UNITED STATES PATENT AND TRADEMARK OFFICE

PRI IO I TIONINO	THE THE PART	EIDOMALLA CON DUCA TORON	Lemanyers		
PPLICATION NO.	FILING DATE	FIRST NAMED INVENTOR	ATTORNEY DOCKET NO.	CONFIRMATION NO	
10/721,168	11/26/2003	Pat A. Bolen	115584-00343	5533	
27557	7590 11/16/2004		EXAM	EXAMINER	
BLANK ROME LLP 600 NEW HAMPSHIRE AVENUE, N.W.			HARVEY, JAMES R		
WASHINGTON, DC 20037		•	ART UNIT	PAPER NUMBER	
			2833

DETAILED ACTION

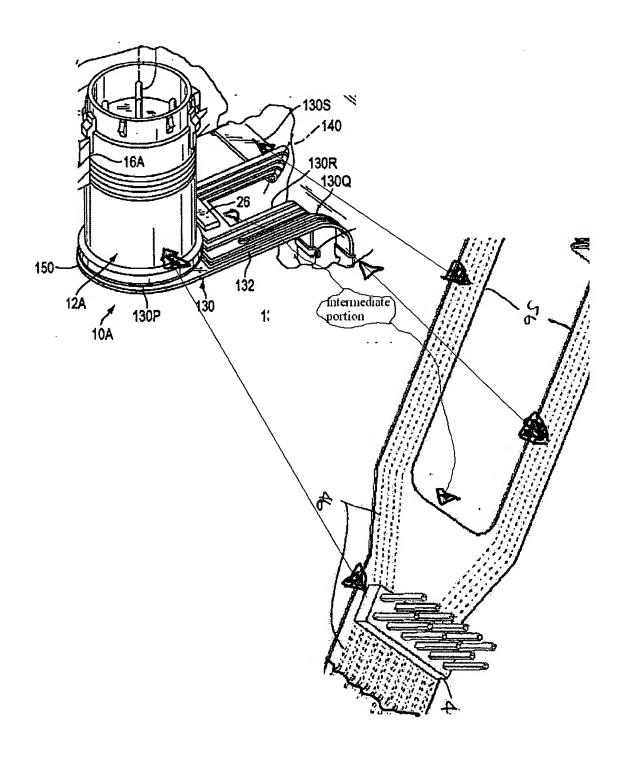
Muzslay shows (figure 10) substantially the same structure as that recited in claims 5 and 9 (see examiner's figure), Muzslay shows the mounting header 12A is located on an intermediate portion (figure 10; (between the two extreme portions (near the lead line of numerals 130S and 130Q; (see attached definition from The American Heritage Dictionary))) of the flat cable 130, and the flat cable 130 further includes two extensions (130S, 130Q) having connectors (column 5, lines 20-23) on the ends thereof.
